Environmental Protection Act 1986

Section 43A

NOTICE OF DECISION TO CONSENT TO CHANGE TO PROPOSAL DURING ASSESSMENT

Ravensthorpe Nickel Project Revised Proposal Assessment No. 2100

Figure 1: New Revised Proposal Authorised Extent

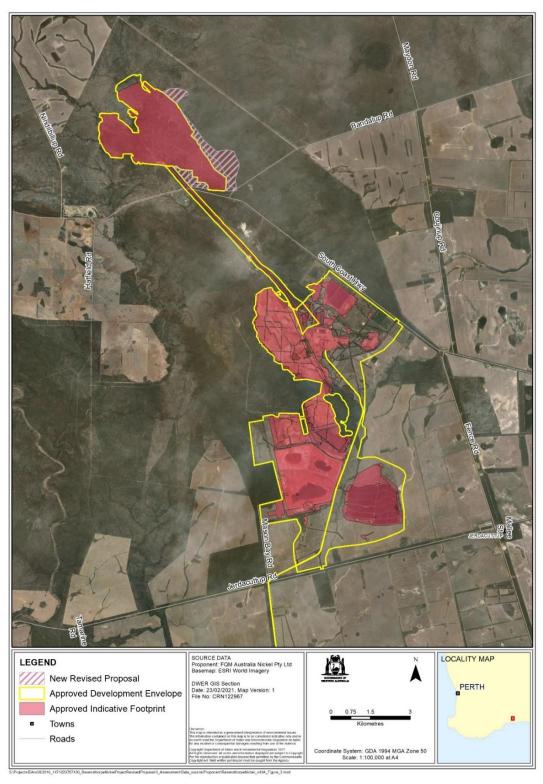
- Removal of the proposed expansion of mining of the Hale-Bopp orebody within the Kunzea similis ssp. mediterranea Community Conservation Area as defined in Statement 633 resulting in a reduction of 29 ha.
- Removal of the realignment of the infrastructure corridor route between the Shoemaker-Levy orebody and the processing plant area resulting in a reduction of 101 ha.
- Removal of the incorporation of neutralised tailings to the reject rocks used to backfill mine pits and re-establish hill topographies.
- Reduction in the amount of clearing of 340 ha at the Shoemaker-Levy expansion area.

Shoemaker-Levy pit, overburden storage area and stockpile	Disturbance of no more than 1,475 ha within the 1,567.3 ha Shoemaker-Levy Development Envelope	Decrease in disturbance by 340 ha	Disturbance of no more than 1135 ha within the 1164 ha Shoemaker-Levy Development Envelope

Figure 2 – Layout of proposed change

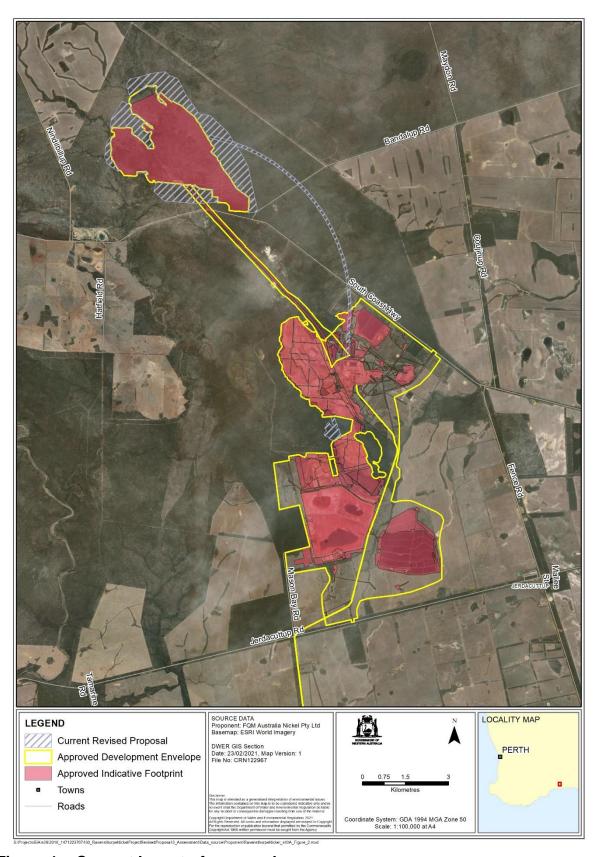
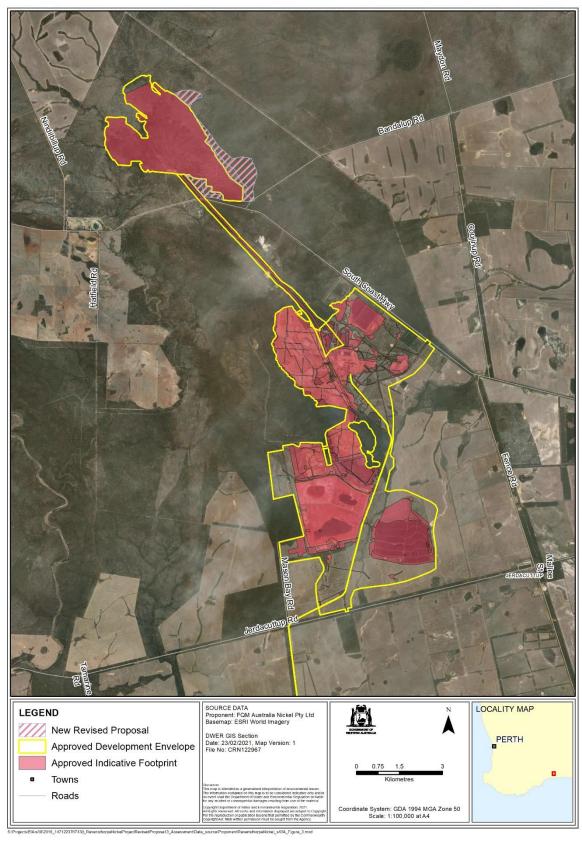
- Removal of the proposed expansion of mining of the Hale-Bopp orebody within the *Kunzea similis ssp. mediterranea* Community Conservation Area as defined in Ministerial Statement 633 resulting in a reduction of 29 ha.
- Removal of the realignment of the infrastructure corridor route between the Shoemaker-Levy orebody and the processing plant area resulting in the reduction of 101 ha.
- Removal of the incorporation of neutralised tailings to the reject rocks used to backfill mine pits and re-establish hill topographies.
- Reduction in the amount of clearing of 340 ha at the Shoemaker-Levy expansion area.

Overall there is a decrease of 470 ha to the disturbance footprint due to modifications of mine pits, key mine infrastructure and other supporting infrastructure. This decrease in disturbance does not introduce any new key environmental factors that were not previously considered.

- Removing the expansion of mining of the Hale-Bopp orebody within the Kunzea similis ssp. mediterranea Community Conservation Area as defined in Ministerial Statement 633 will reduce the disturbance impacts by 29 ha.
- Decrease in the expansion of mining of the Shoemaker-Levy ore body will reduce the clearing of native vegetation by 340 ha.
- Removing the realignment of the infrastructure corridor route between the Shoemaker-Levy orebody and the processing plant area will reduce the disturbance impacts by 101 ha.
- Removing incorporating neutralised tailings to the reject rocks used to backfill mine pits and re-establish hill topographies removes potential impacts to Inland Waters.
